Staff Report & Recommendation

DRB18-0322

4354 Alton Road - NORTH PARCEL

DATE: November 06, 2018

Portion of the March 01, 1923 Plat of Nautilus Subdivision (subject property Lot 21 of Block 6)

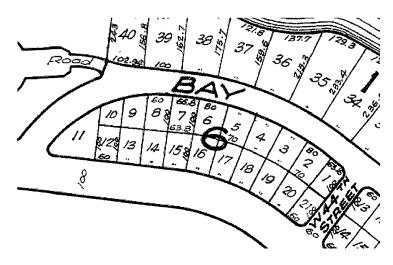
As a result of the approved lot split, the subject property has been divided along original platted lot lines (lots 20 and 21 of Block 6). Since the divided lots taper along this portion of

Alton Road, the actual lot width for the parcel is 60'-6". The platted width of this property at the front property line is 60'-0" and the width of the rear property line is 61.58'. However, the lot width for zoning analysis is measured at 20' setback from the front property line, and in this case, the lot width is slightly above 60'. As such, the minimum required setback for the interior side is 10'-0", for lots greater than 60' in width. The applicant is proposing a 7'-6" south side yard setback, as if the lot width were 60'-0". As the proposed setback of 7'-6" is the typical setback for 60-foot wide lots; staff is supportive of the variance and acknowledges the practical difficulties related to the side setbacks resulting from the irregular shape of the lot. Staff would note that the north side street complies with the required 15'-0" setback. Staff is supportive of variances #1 and #2 as they are fundamentally linked to one another.
